Land at Hamble Airfield, Hamble-le-Rice

HIGHWAY IMPACT REVIEW

for Sand and Gravel Extraction
on behalf of Hamble Parish Council

2023/6992/HIR01

Summary: Pedestrians and cyclists are likely to travel along the existing verge

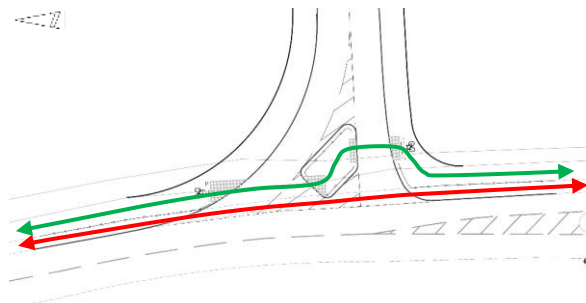
4.6.1 Problem A.4 'Pedestrians and cyclists are likely to travel along the existing verge' related to the suggestion that the deterrent paving is installed within the verge besides the proposed guardrailing which has been put to the LHA for consideration. It is RGP's recommendation that deterrent paving is installed.

Hamble Lane benefits from a shared footway cycleway along the eastern side of the carriageway that is offset from the carriageway by a one metre wide grass verge and allows access between The Hamble School to the north and Hamble-le-Rice to the south. As observed, the existing shared footway cycleway accommodates a high footfall particularly before and after the school day with users travelling along the grass verge as well as the footway cycleway. The proposals include the provision of a priority access off the eastern side of Hamble Lane. As part of the proposals, an uncontrolled crossing point is to be provided which benefits from a refuge island and guardrailling is to be installed to guide users towards the crossing point. It is though, however, that a number of pedestrians and cyclists will continue along the verge on the carriageway side of the guardrailling and attempt to cross the proposed junction along the edge of the Hamble Lane carriageway. Due to the seating position and eye height of a driver travelling in a Heavy Goods Vehicle, visibility in close proximity is very restricted and the Audit Team have concerns that a pedestrian or cyclist crossing in front of a Heavy Goods Vehicle will not be seen leading to a vehicle to cyclist / pedestrian collision.

<p>DESIGN ORGANISATION RESPONSE provided by i-Transport on the 2nd December '22 following formal issue of this Stage 1 Road Safety Audit on the 30th November '22.</p>	
<p>Considered – There is potential to install deterrent paving to prevent the pedestrians and cyclists from using the verge and travelling on the wrong side of the pedestrian guard railing, if considered necessary by Hampshire County Council – the Local Highway Authority.</p>	
<p>AUDITOR'S VIEW OF DESIGN ORGANISATION RESPONSE dated 2nd December '22</p>	
<p><i>Confirmation that deterrent paving could be provided and will be further considered, addresses the road safety concern at this stage.</i></p>	
<p>A.5</p>	<p>TRAFFIC SIGNS, CARRIAGEWAY MARKINGS AND LIGHTING</p>
	<p><i>No Road Safety Concerns regarding TRAFFIC SIGNS, CARRIAGEWAY MARKINGS AND LIGHTING have been raised at this stage</i></p>

DRAWING No: ITB13040-SK-013 REV: -

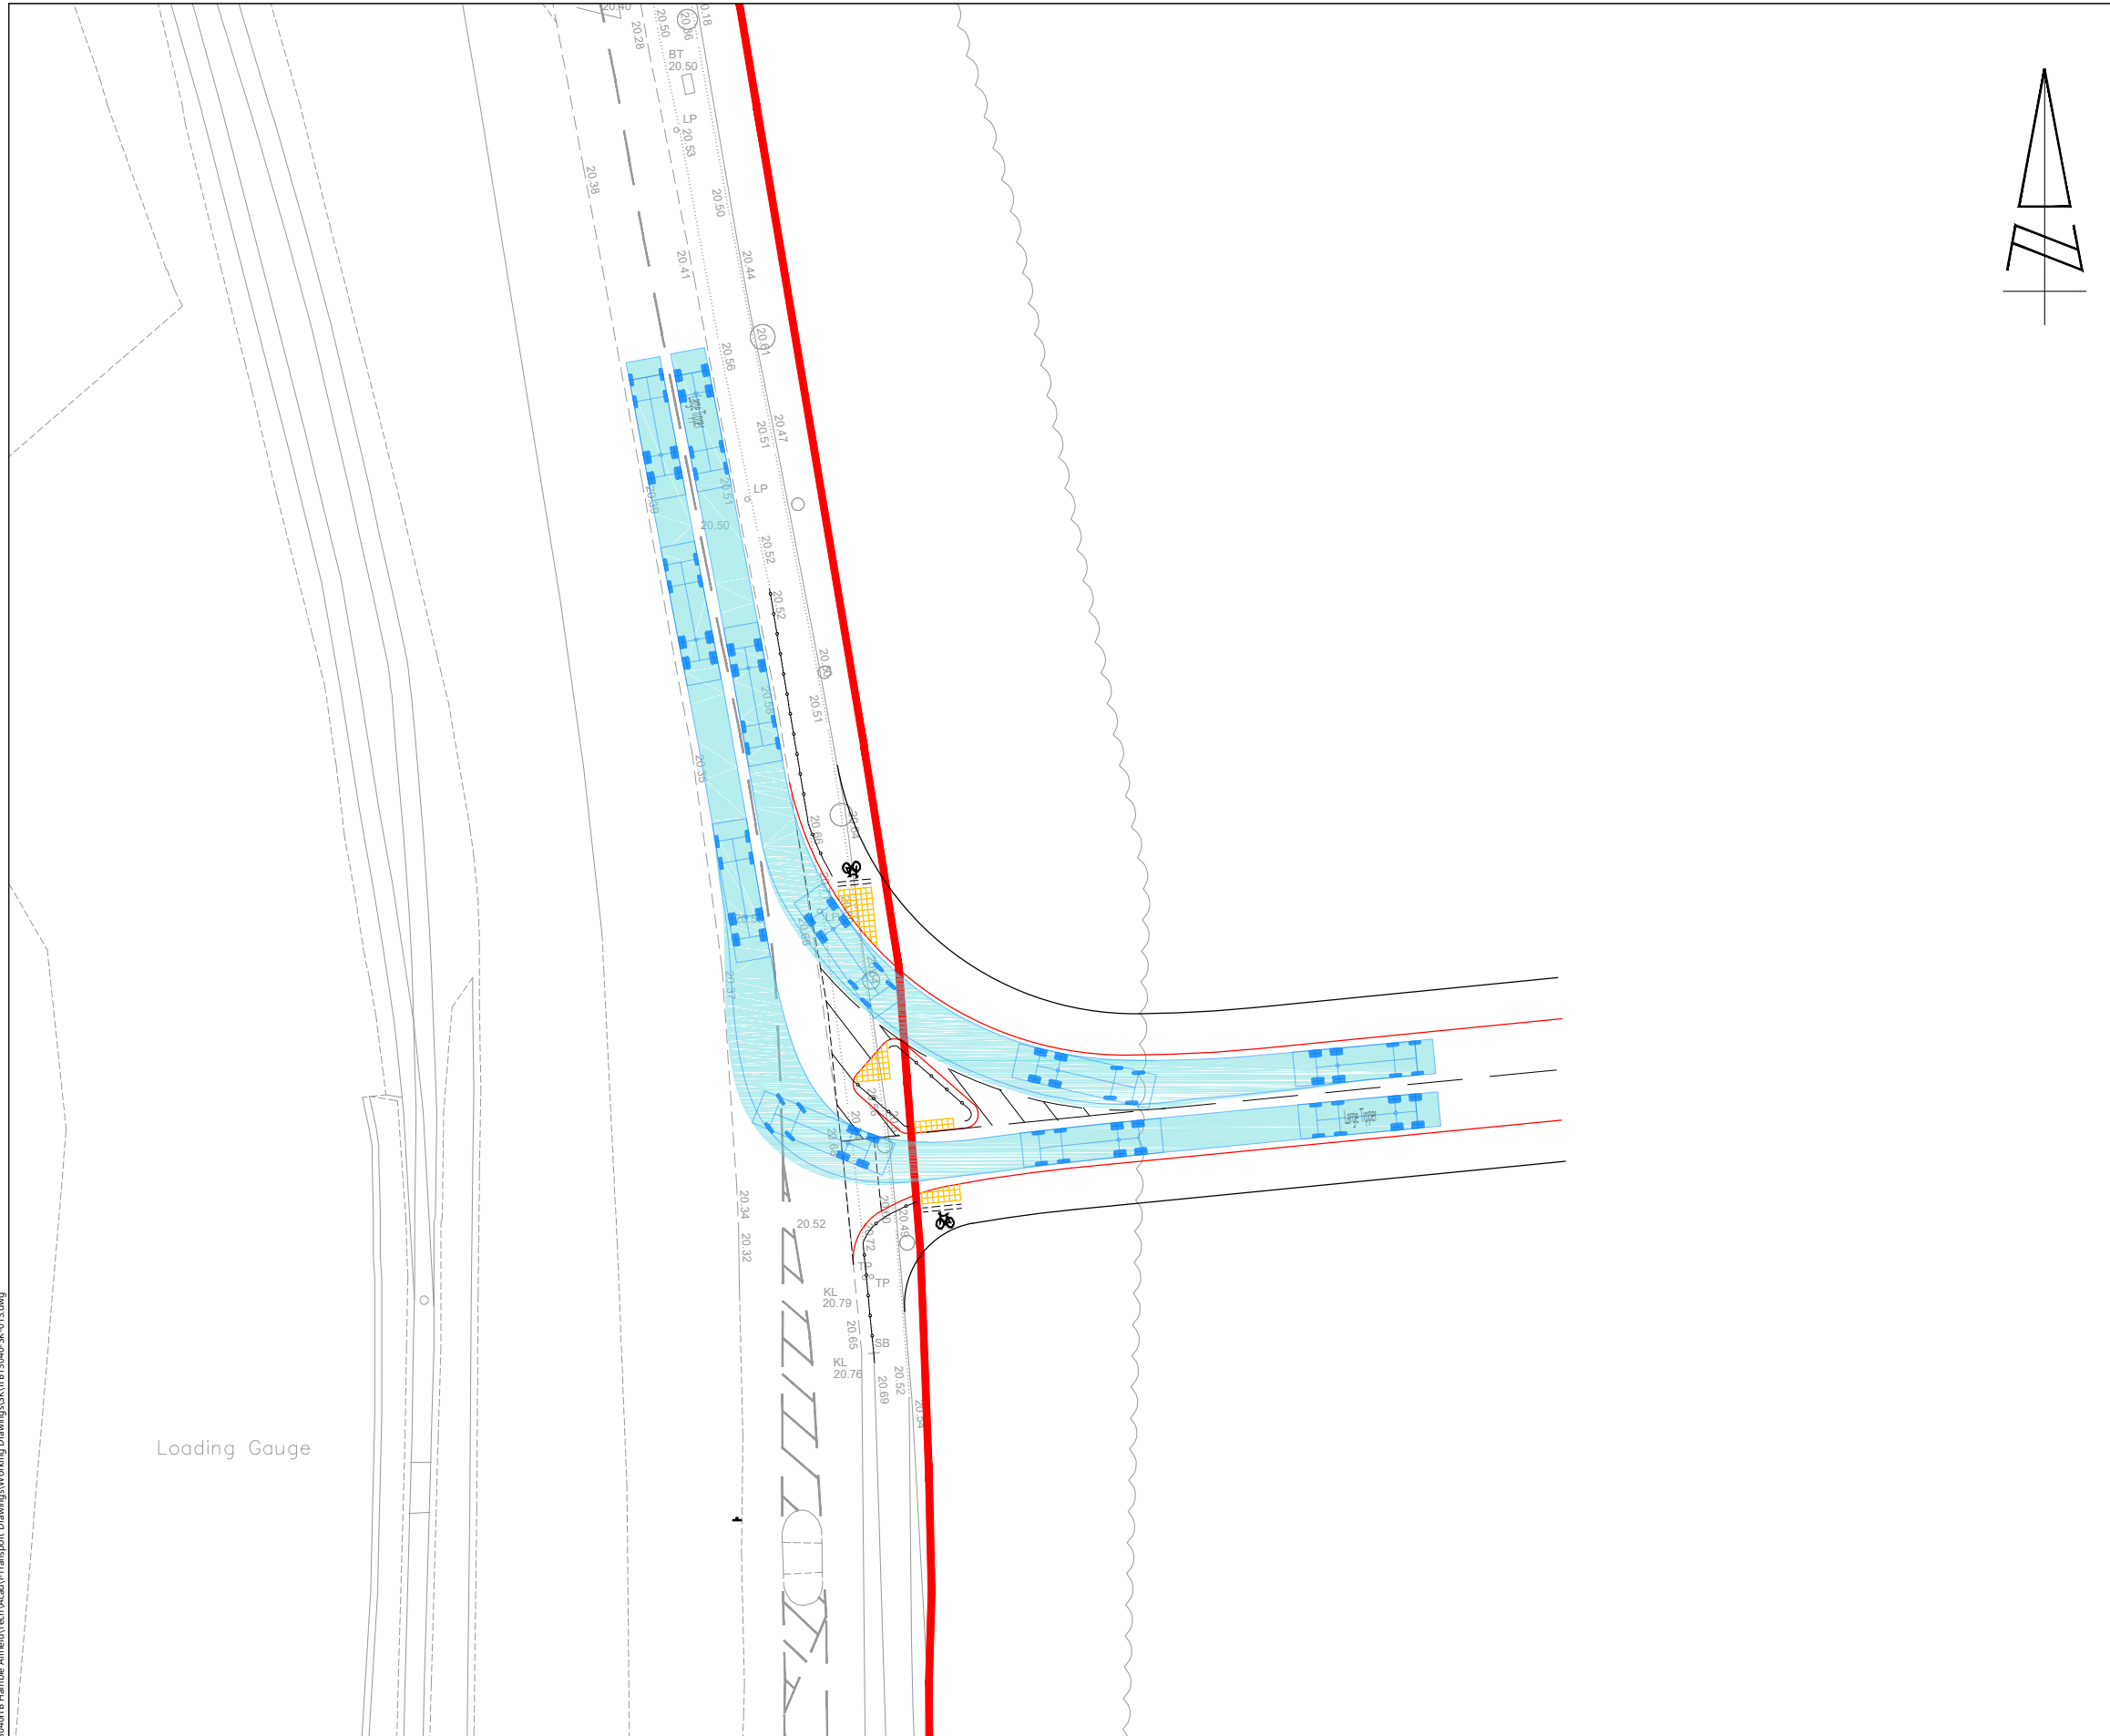
4.4.1 With reference to Problem A.2 '*Geometric parameters do not allow for even a small deviation from the swept path illustrated*' the auditors recommended that the geometric parameters of the proposed site access are increased to ensure adequate space for vehicle manoeuvres'.

4.4.2 The design audit response explained: '*Swept path analysis of the proposed access has been undertaken for a large tipper truck, as shown on drawing ITB13040-SK-013, which demonstrates that vehicles regularly anticipated to use the proposed site access junction can enter and egress the site safely*'. RGP are of the view that the manoeuvres shown are still incredibly tight and as the auditor explained leaves no margin for error.

4.4.3 The development proposals would result in 144 two-way HGV movements per day that as illustrated in the drawing would have to be conducted perfectly as any deviation from the path illustrated, would lead to HGVs encroaching onto the footway which could lead to a pedestrians/cyclist collision. RGP therefore do not consider that this matter has been adequately addressed.

<p>DESIGN ORGANISATION RESPONSE provided by i-Transport on the 2nd December '22 following formal issue of this Stage 1 Road Safety Audit on the 30th November '22.</p>	
<p>Swept path analysis has been undertaken for a 16.5m long articulated vehicle to demonstrate the 'worst case scenario'. It is however envisaged that the majority of HGV movements to / from the site will be undertaken by 20 tonne rigid vehicles (which have an approximate length of 10 metres) with larger articulated vehicles only observed on a rare occasion. Swept path analysis of the proposed access has been undertaken for a large tipper truck, as shown on drawing ITB13040-SK-013, which demonstrates that vehicles regularly anticipated to use the proposed site access junction can enter and egress the site safely.</p>	
<p>AUDITOR'S VIEW OF DESIGN ORGANISATION RESPONSE dated 2nd December '22</p>	
<p><i>Confirmation that the majority of vehicles that access the proposed minerals extraction site, will be 20 tonne rigid vehicles which can manoeuvre safely at the proposed junction and that articulated vehicles will not be regularly observed but can be accommodated, addresses the road safety concern at this stage.</i></p>
